Product Change Notice: #VE20220418

RE: Product Branding Change

Product change:

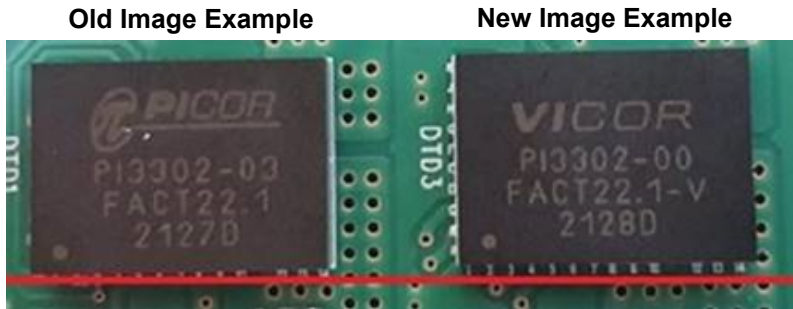
Specific products have a new brand marking.
Product marking changes from the Picor mark to the Vicor mark.
This is a cosmetic change only. Change is due to brand consolidation.

**This package detail may or may not be present on all Buck and Buck-Boost parts. The detail varies upon our sourcing of material.*
